MUNICIPALITY OF CLARINGTON

*TRIAGE REPORT FOR*  
INSPECTION – RINK REFRIGERATION & PAD  
NEWCASTLE MEMORIAL ARENA

103 CAROLINE ST. W, NEWCASTLE, ON

SEPTEMBER 23, 2020

Figure 16: Rusting on ceiling beams

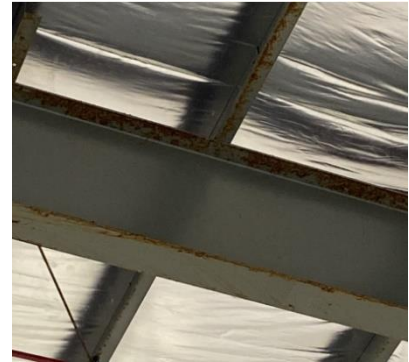
- No information on the age of the two dehumidifier units is available and the units were not accessible.
- The units were not in use during the inspection as the rink was out of season, however rusting was observed in the metal structure of the roof showing inadequate dehumidification has been an ongoing issue.

Category	Recommended Action
Immediate Actions	<ul style="list-style-type: none"> <li>• Inspect the dehumidifiers to ensure that both units are working properly.</li> <li>• Continue regular maintenance on the units.</li> </ul>
Short-Term Actions	
Capital Expenditure Planning	<ul style="list-style-type: none"> <li>• Plan to replace the dehumidifiers within 5 years.                             <ul style="list-style-type: none"> <li>○ <b>Consider a central air handling unit with built in dehumidification to provide proper zone conditioning and prevent moisture build ups leading to premature building structural damage and mold growth.</b></li> <li>○ <b>The new dehumidification units should be integrated into a central control system to ensure ongoing monitoring and humidity control in the rink zone.</b></li> </ul> </li> </ul>

Figure 17: Health and safety danger ranges for visualization and decision-making.

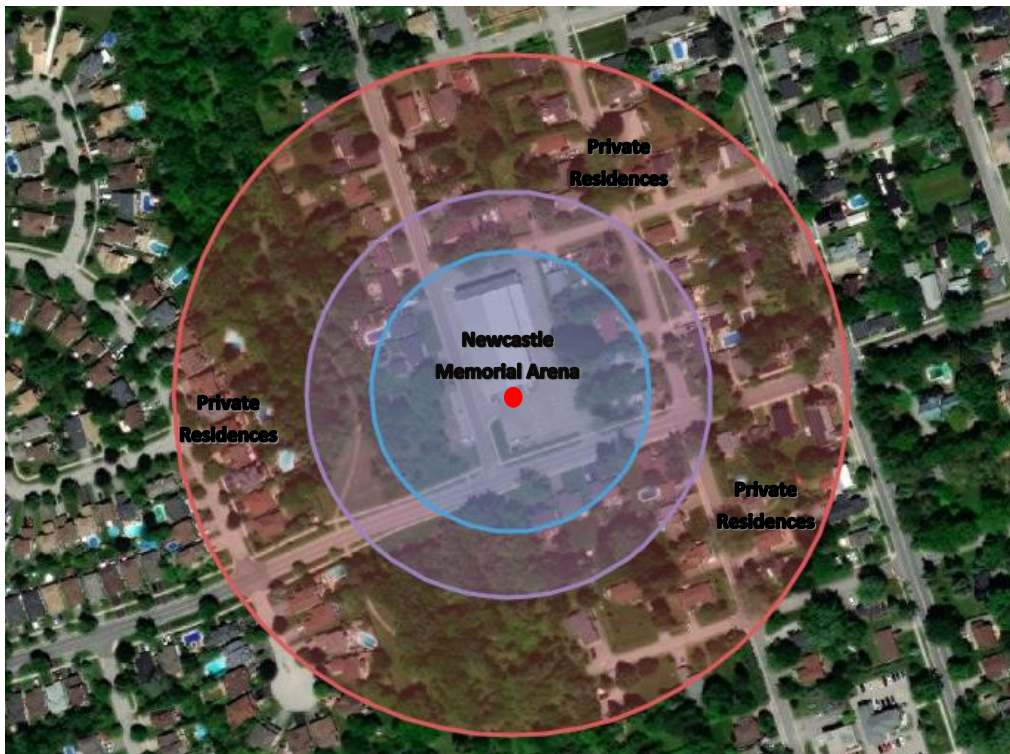
- IDLH range does not factor in wind distribution and refrigerant charges have been estimated as no detailed signage is available. These ranges are presented for visualization and decision-making purposes only.

- The existing refrigeration plant range, shown in red above, covers more than 50 residential properties.
- Low charge plant (60% reduction), shown in purple above, would result in approximately 35 properties being removed from the immediately dangerous to life and health range.

- Ultra-low charge plant (80% reduction), shown in blue above, would limit dispersal to the arena and the nearest 6 residential properties.
- Switching to an alternate, lower toxicity, environmentally sustainable A1 category refrigerant could remove the impact to surrounding buildings entirely and eliminate issues with toxicity and flammability.

- Reduction in the IDLH range provides more time for people to evacuate and emergency teams to arrive, as the charge disperses slower. These ranges must be considered even if on-site ammonia evacuation equipment is used, as the refrigerant is still on site.

Figure 18: Building overview with recommended dressing room addition in blue.

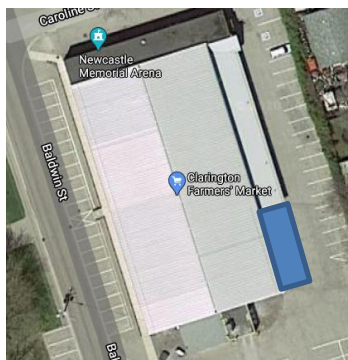
The building currently has 4 dressing rooms, while 6 dressing rooms is the current standard. It is recommended that two additional dressing rooms be added onto the building as part of any building overhaul.

APPENDIX A  
B52-18 COMPLIANCE PHOTOS

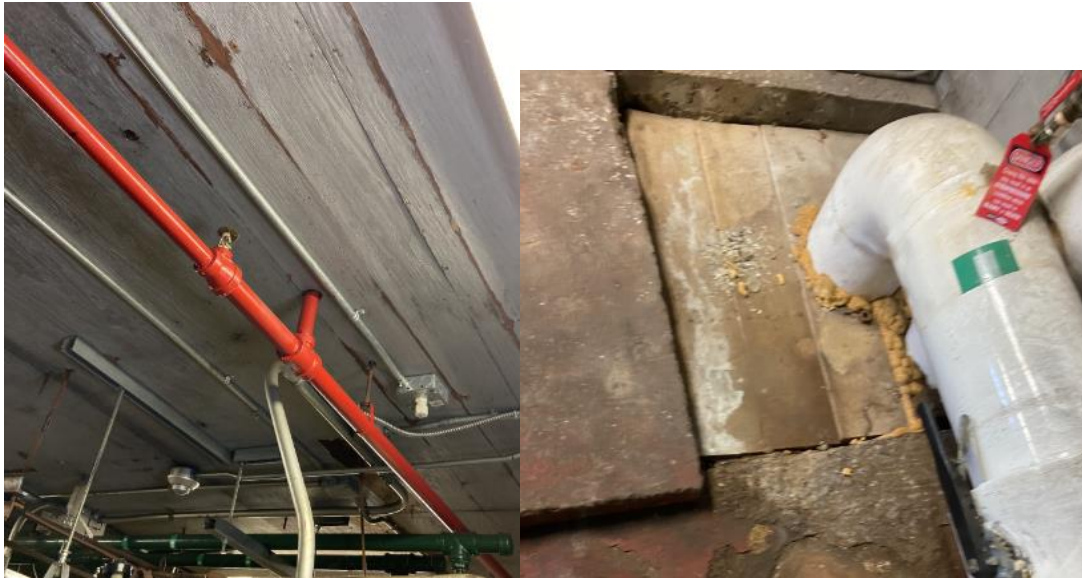
6.1.3 Evaporative condenser installed on the roof has no permanently accessible ladder, is on the edge, and has no railing

6.3 c) Room not tightly sealed – daylight clearly visible through door, aging window frame

6.3 d) Ceiling and trench cover not made of fire-resistant material

6.3 f) Pipes passing through walls and ceiling not properly sealed

6.3 j) Refrigerant detector reporting inaccurate value

B.2.9 Emergency valve less than 7ft above the ground
